VOLVO CONSTRUCTION EQUIPMENT SERVICE BULLETIN

Language Code GB	Group 975	Product CEX	No. 42 K	Version 1	Date 2008-09-02	Page 1/1
Applies to models EC15B XR, EC15B XT, EC15B XTV, EC20B XT, EC20B XTV, EC25

Dipper arm welding process improvement

Fig.1 Dipper arm
1 Identification number

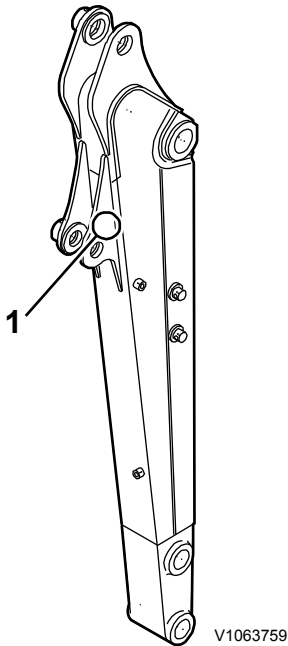
In some cases, there can be cracks in the dipper arm welding.

Supplier welding process has been checked and updated. The following improvement has been introduced in production with effect from dipper arm serial No. according to table below.

Replace the dipper arm.

Send a report and a photo showing the cracks, together with the dipper identification number to Customer Support by Techline call or e-mail.
